# **Ivilo Heights Subdivision Final Drainage Report**

**Colorado Springs, El Paso County, Colorado**

**April 2024**

**PCD No. SF245**

SHEET # **FIG.4**

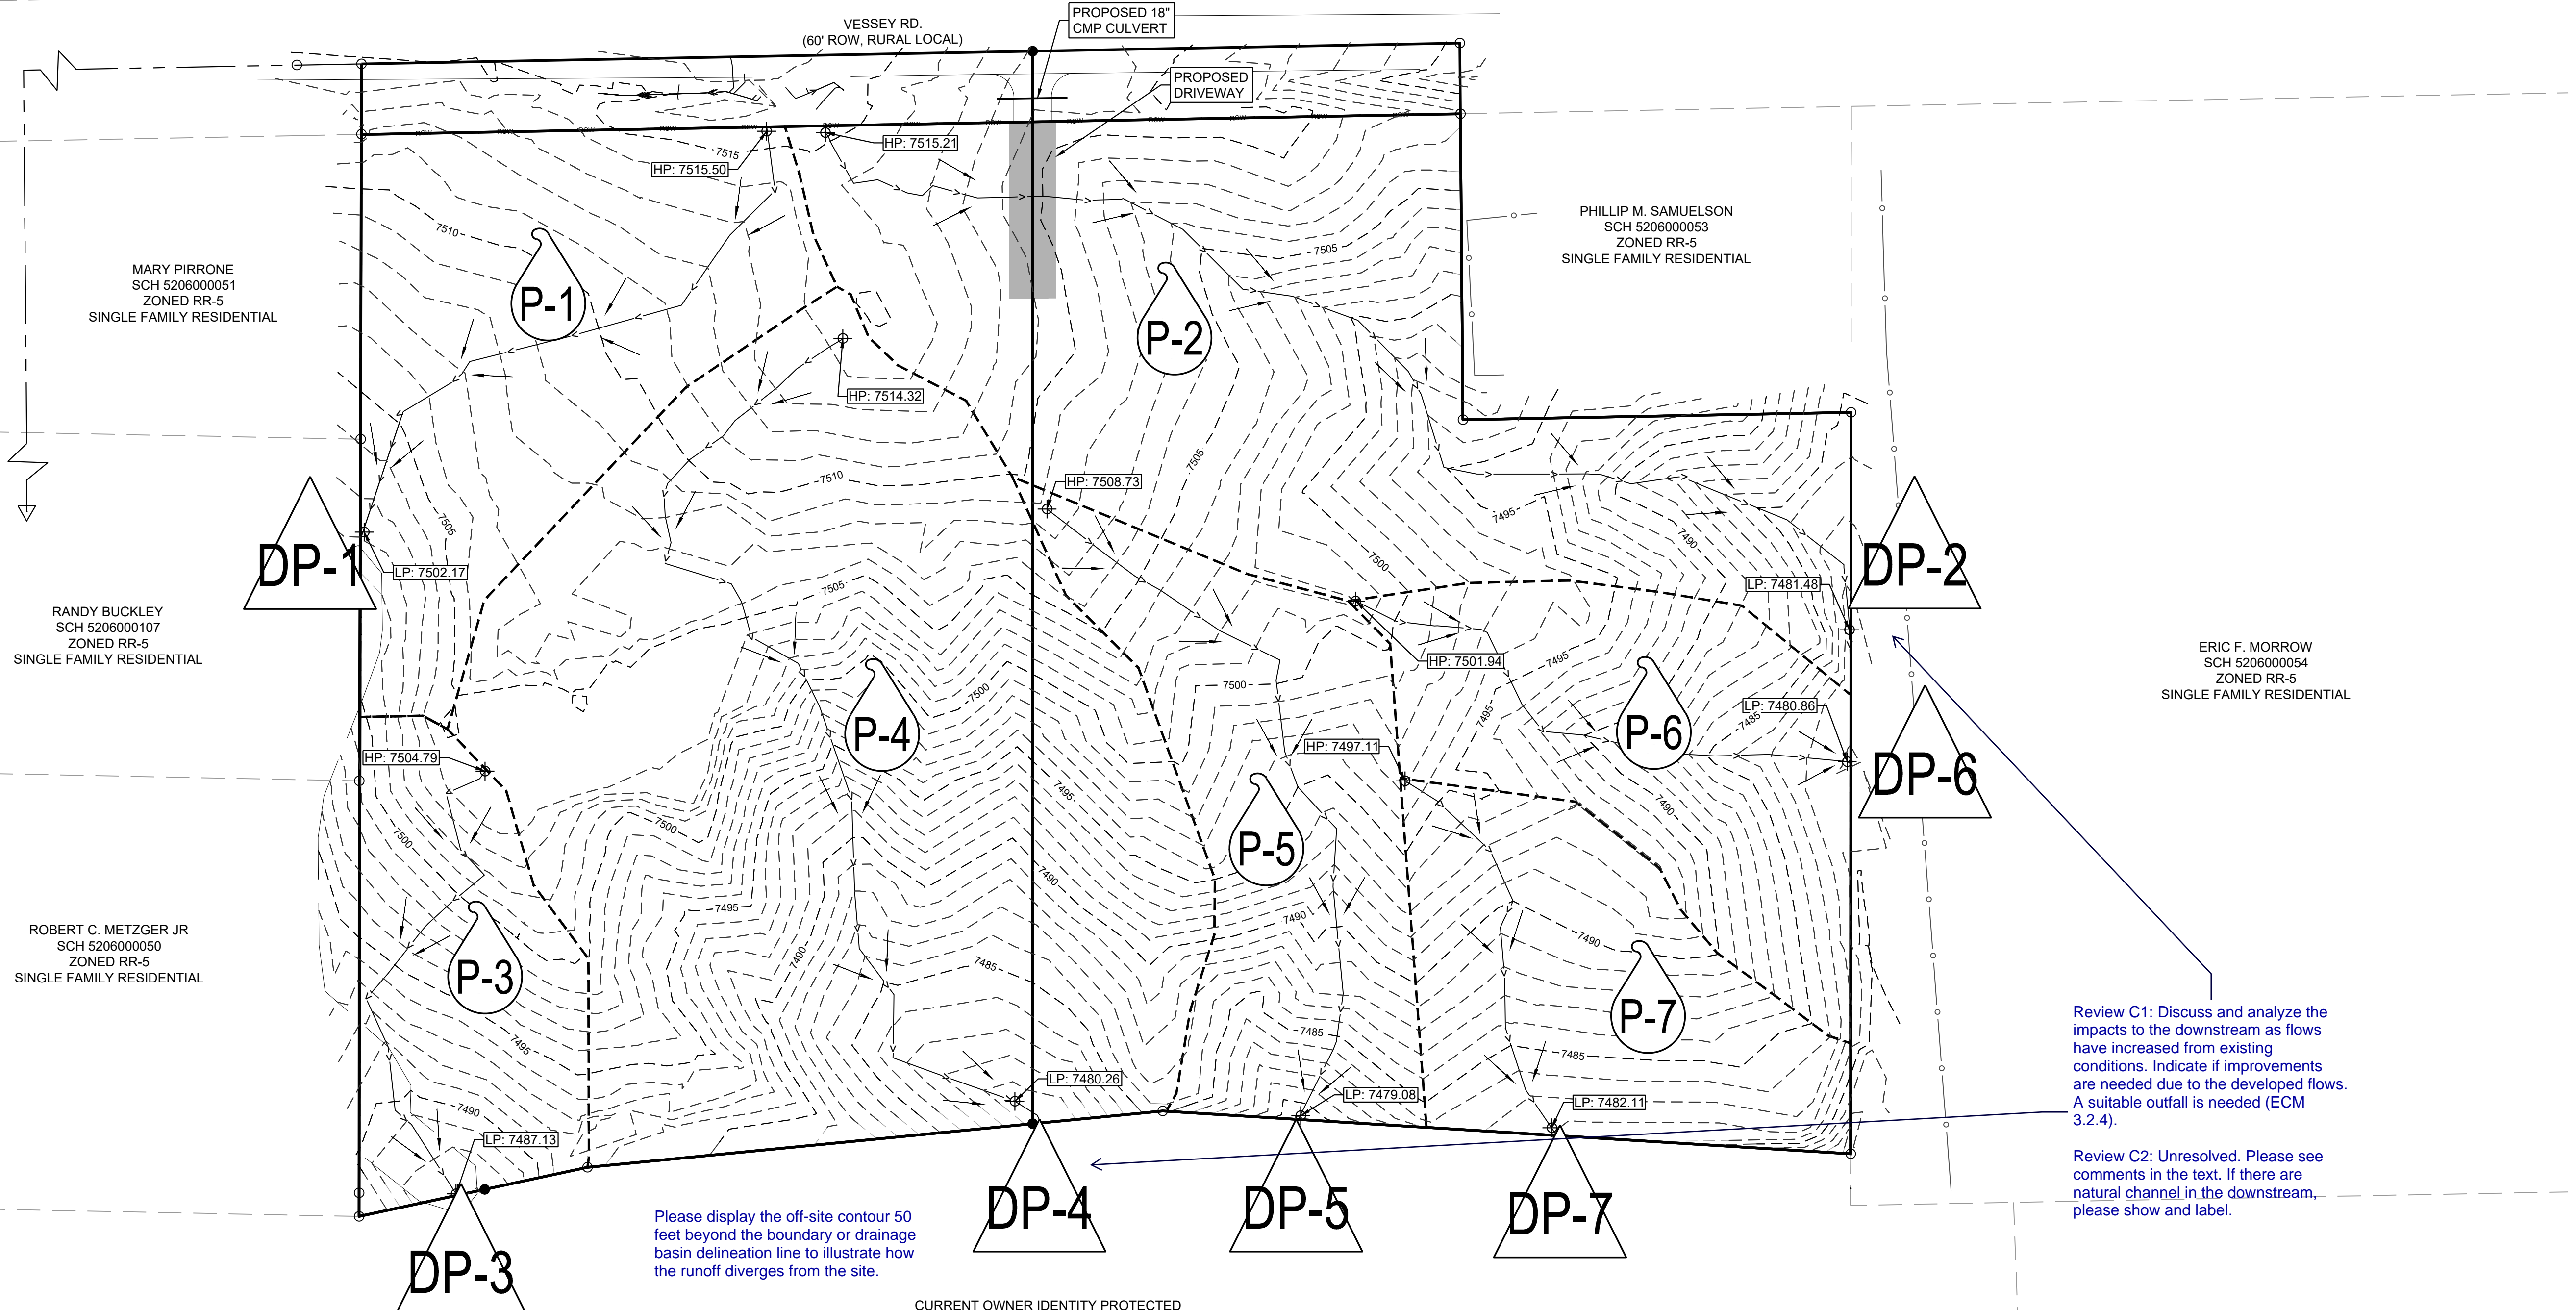
Review C2: Unresolved. Please see comments in the text. If there are natural channel in the downstream, please show and label.
